**DOCUMENT 00 90 00
ADDENDUM**

ADDENDUM NO. [1] Date: August 14, 2019

**RE: LANESBORO PUBLIC SCHOOLS
 ADDITION AND REMODEL
 100 KIRKWOOD ST EAST
 LANESBORO, MN 55949
 HSR 18063**

**FROM: HSR Associates, Inc
 100 Milwaukee Street
 La Crosse, WI 54603
 (608) 784-1830**

E092L

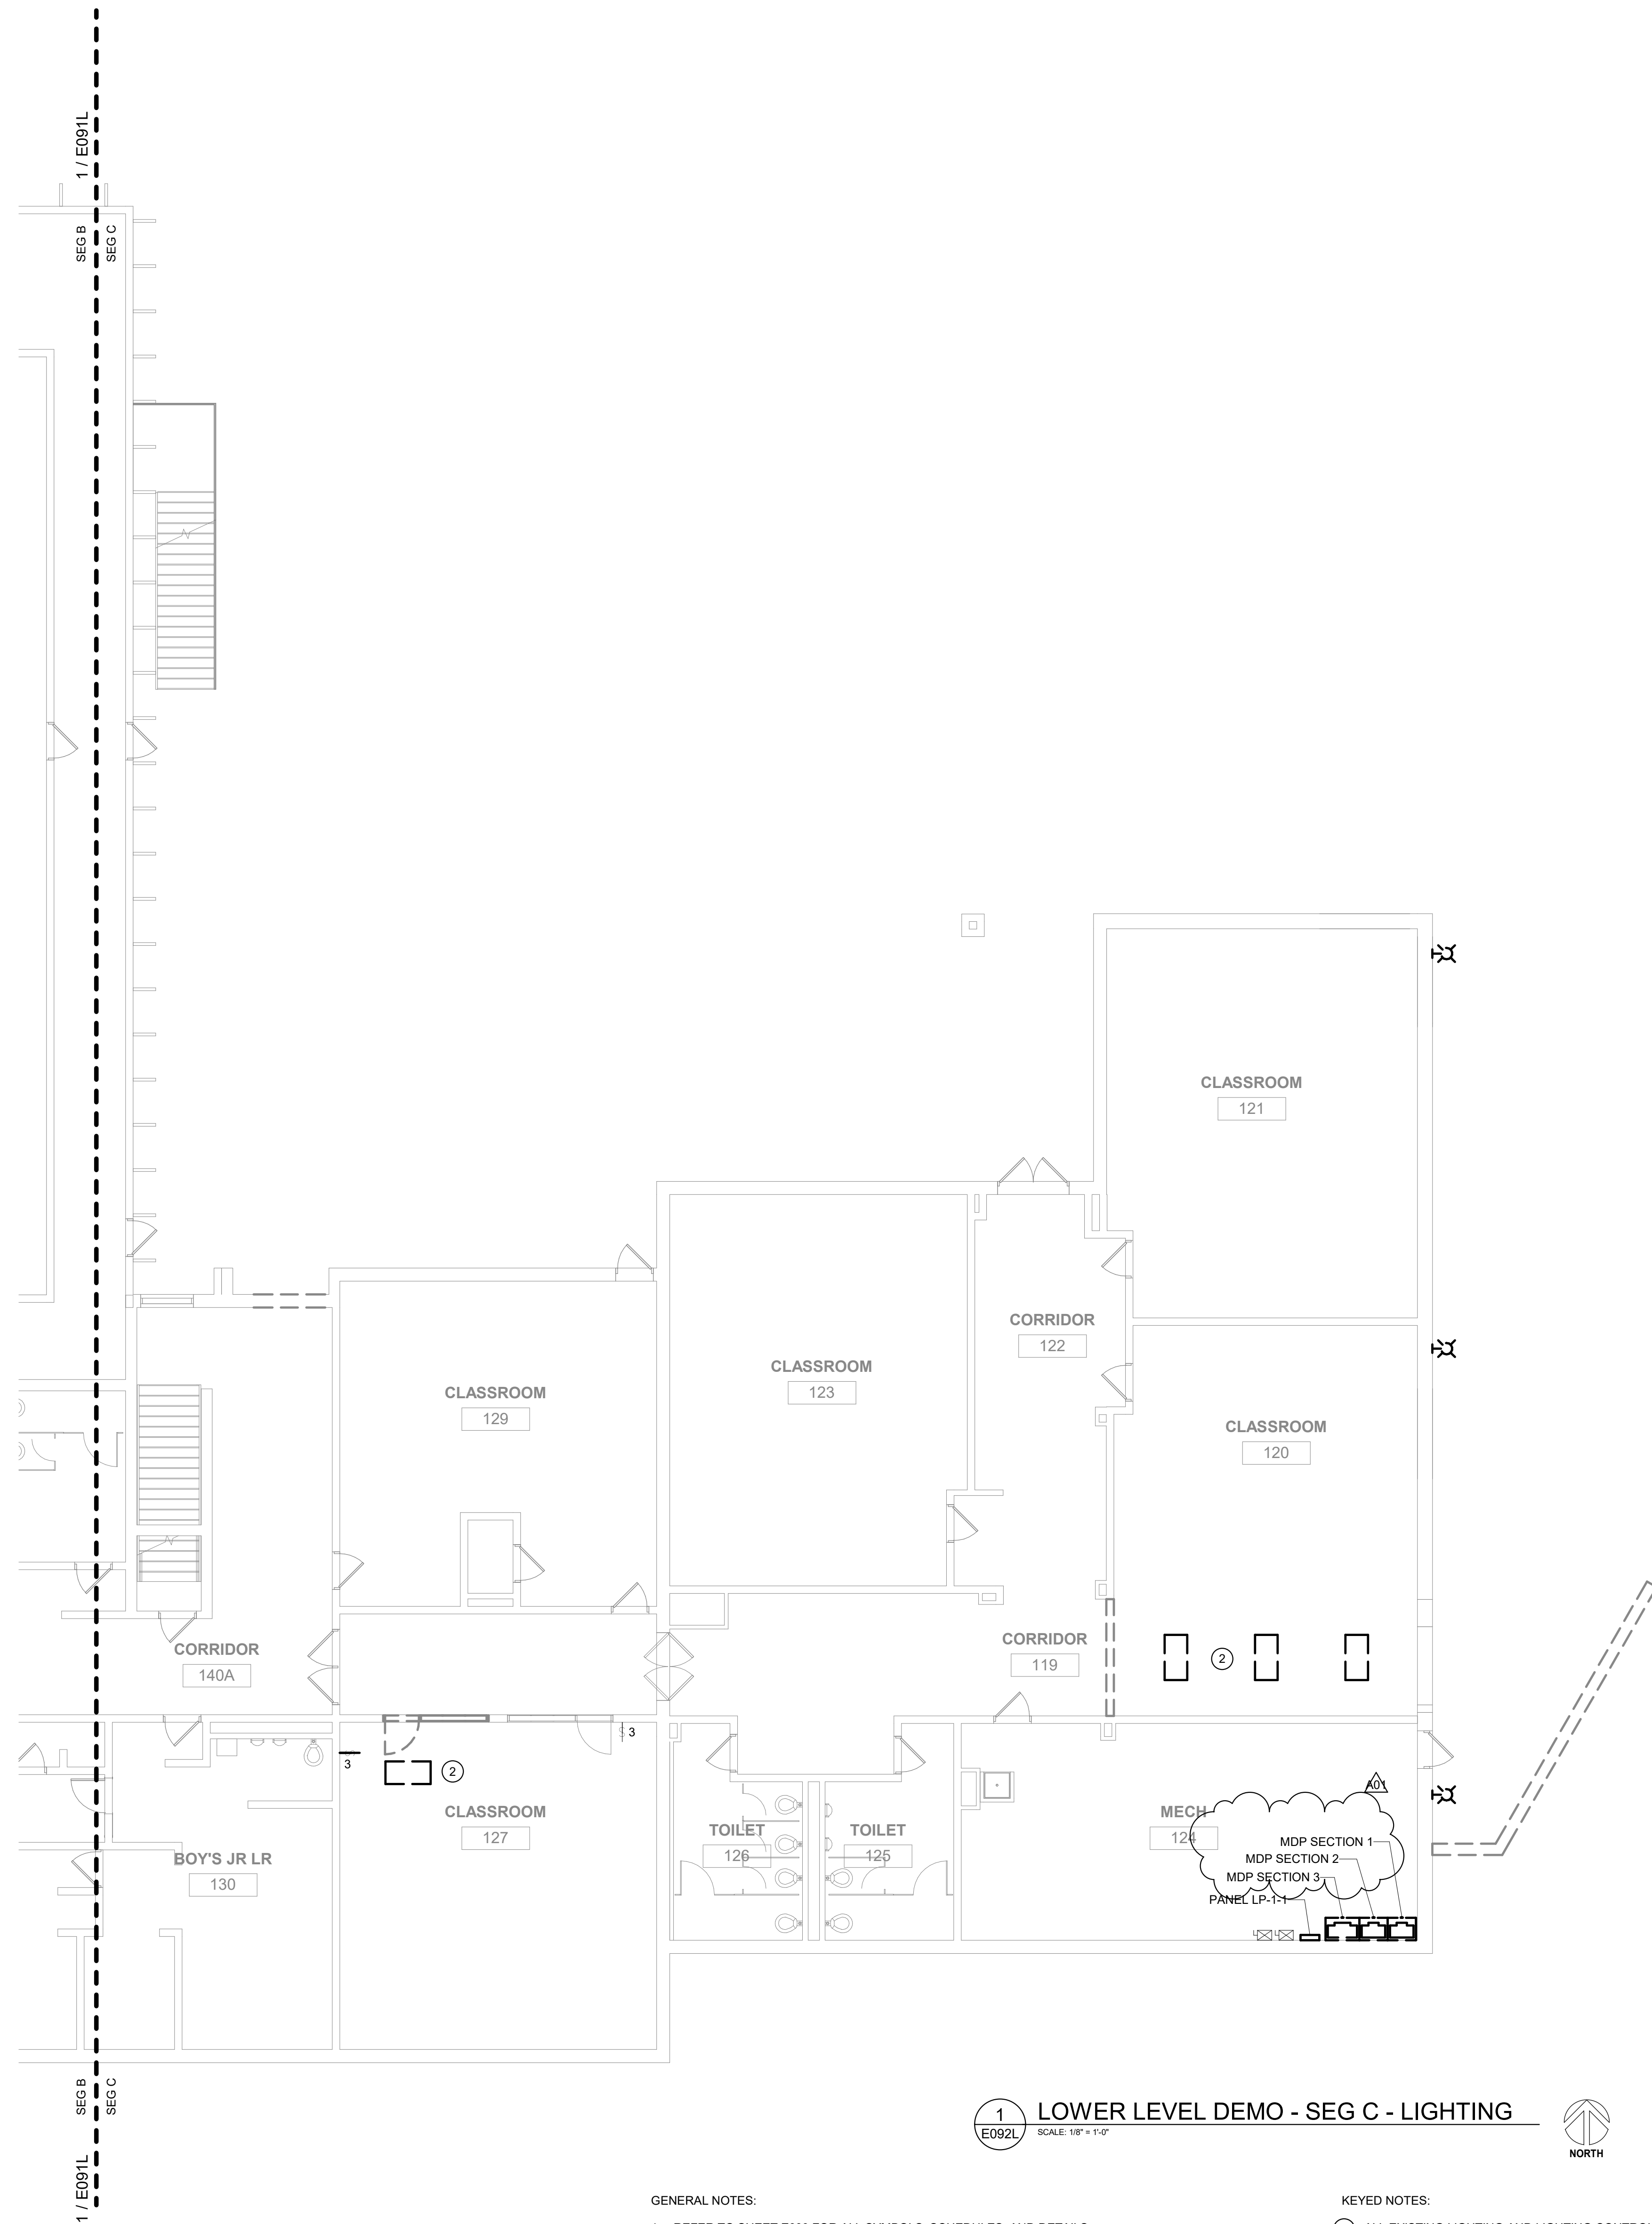
44. Sheet E092L LOWER LEVEL DEMO – SEGMENT C - LIGHTING 30 x 42 attached hereto
 - a. Revisions clouded on Drawing.
 - b. Revise MDP section names, as shown.

E092P

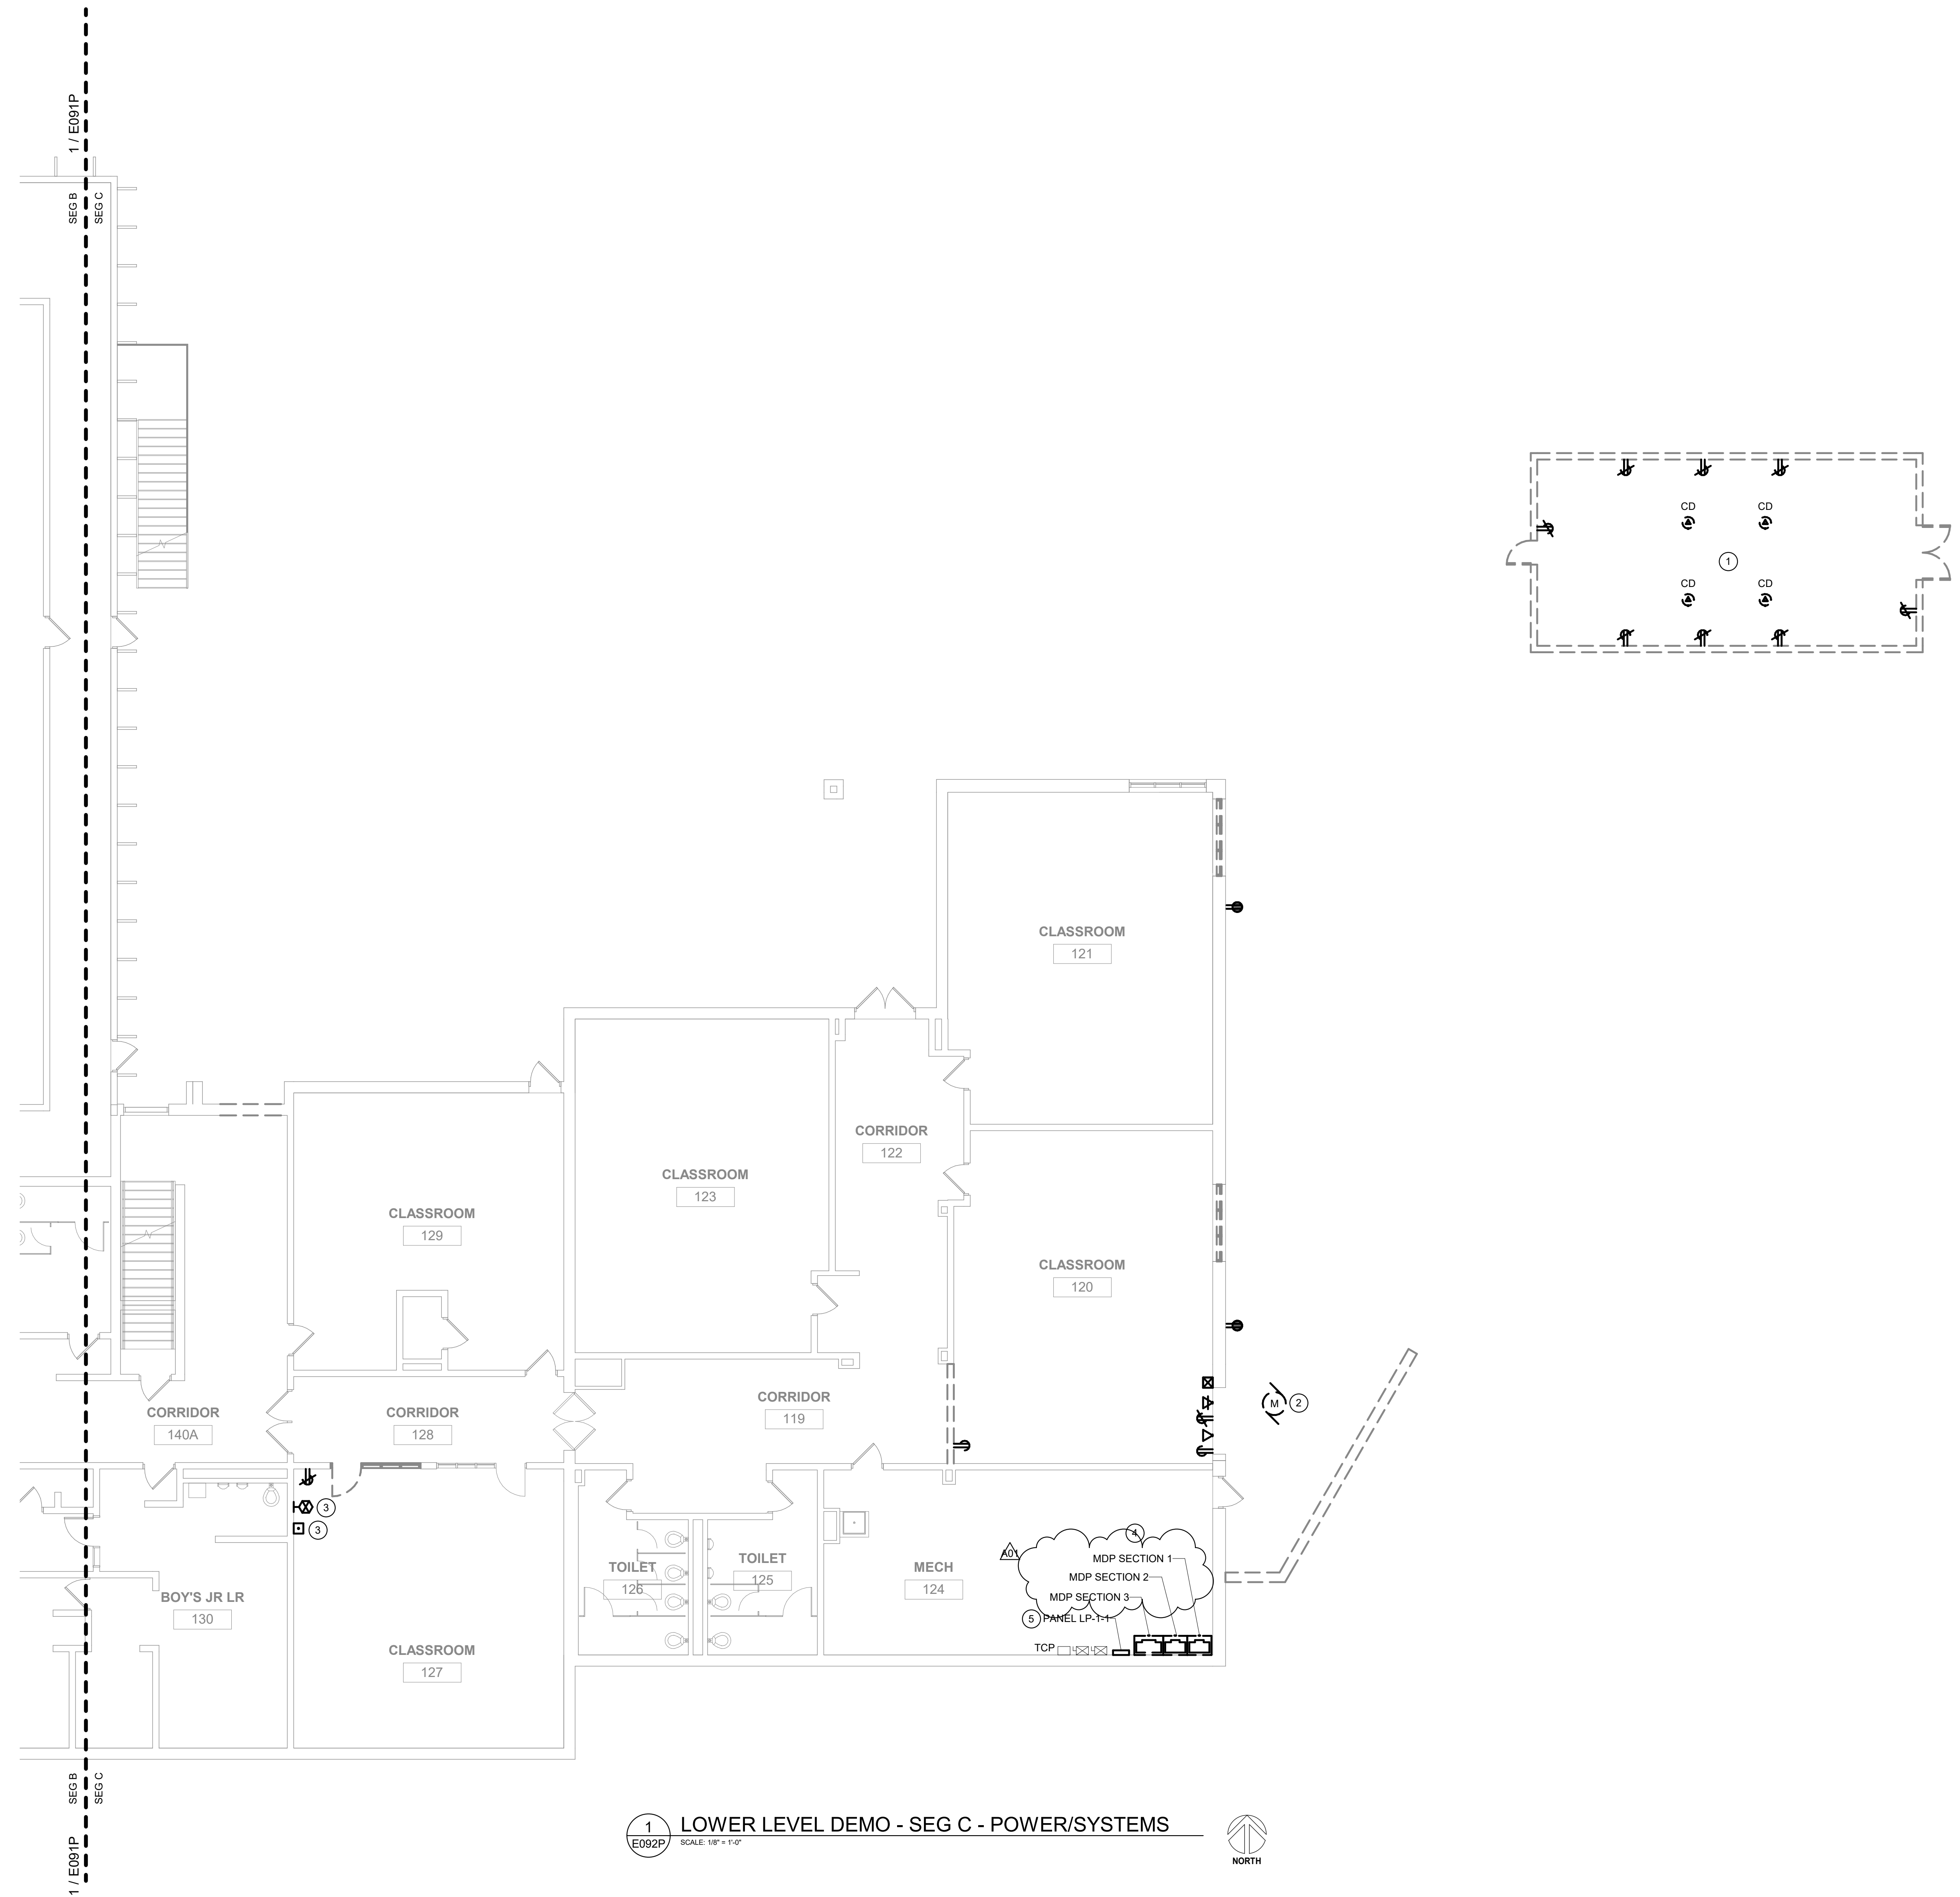
45. Sheet E092P LOWER LEVEL DEMO - SEG C - POWER/SYSTEMS 30 x 42 attached hereto
 - a. Revisions clouded on Drawing.
 - b. Revise MDP section names, as shown.

E094L

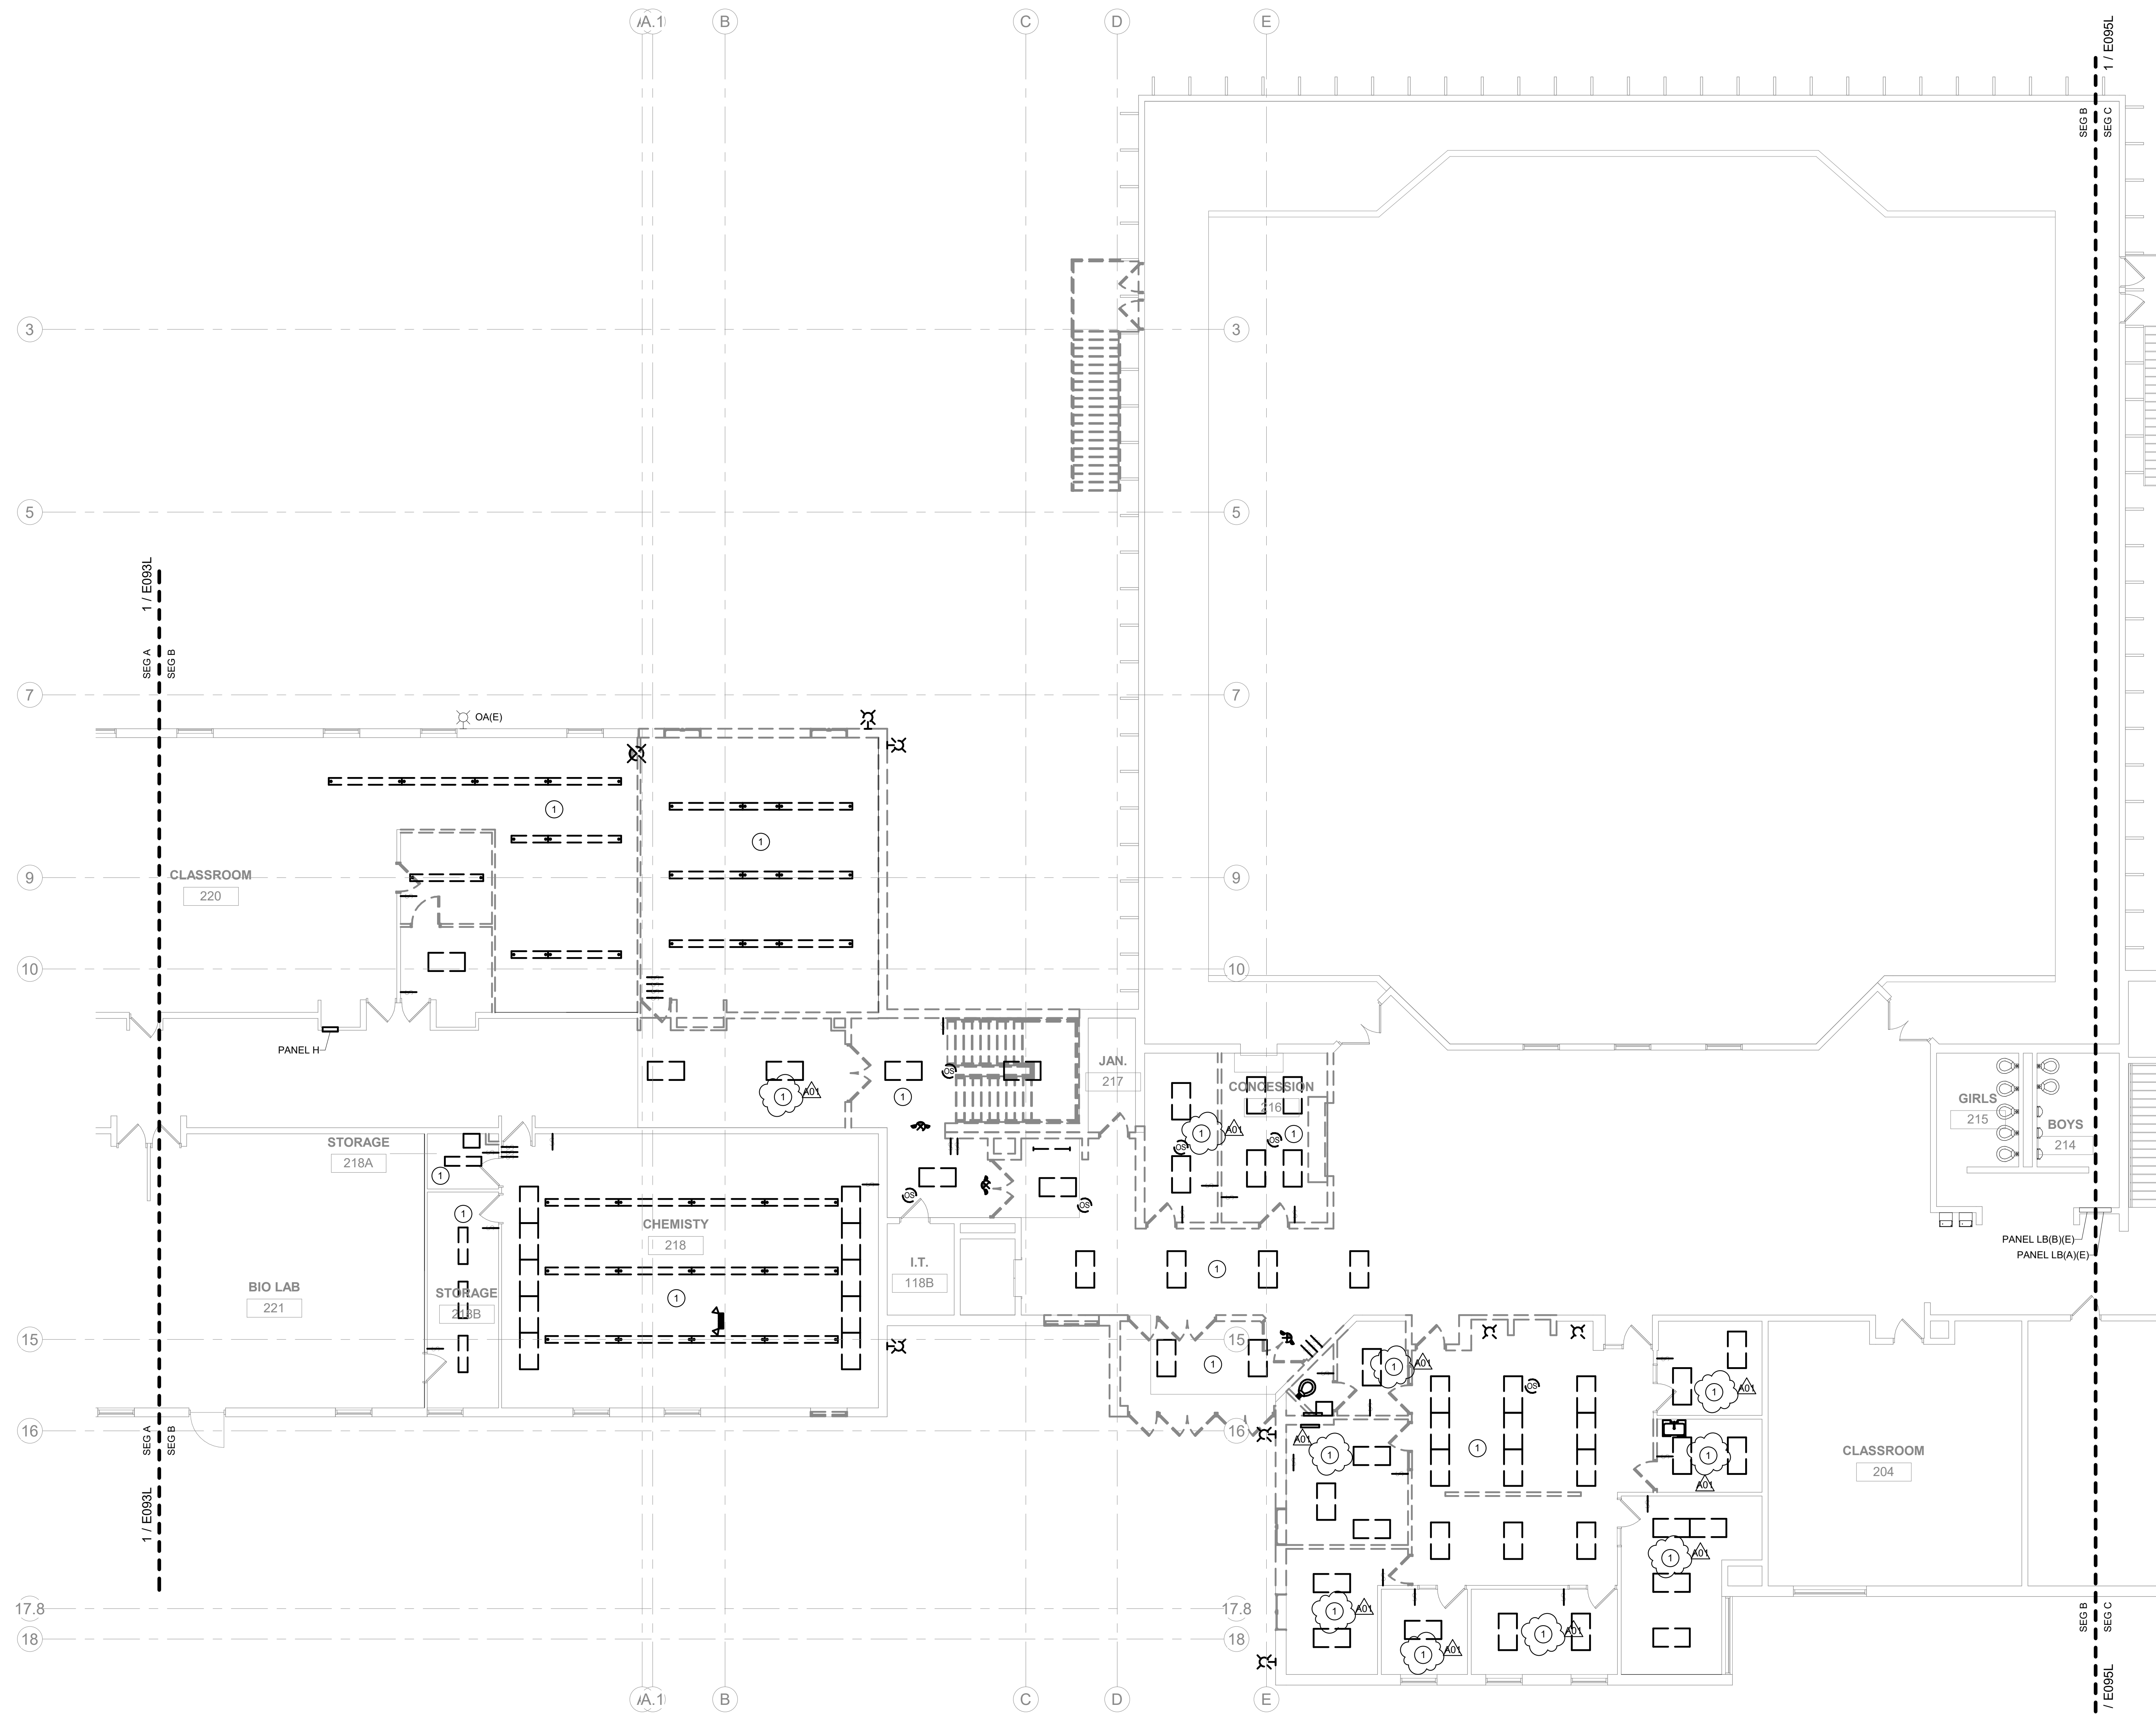
46. Sheet E094L UPPER LEVEL DEMO – SEGMENT B - LIGHTING 30 x 42 attached hereto
 - a. Revisions clouded on Drawing.
 - b. Add keyed note one to highlighted areas to clarify demolition work, as shown.
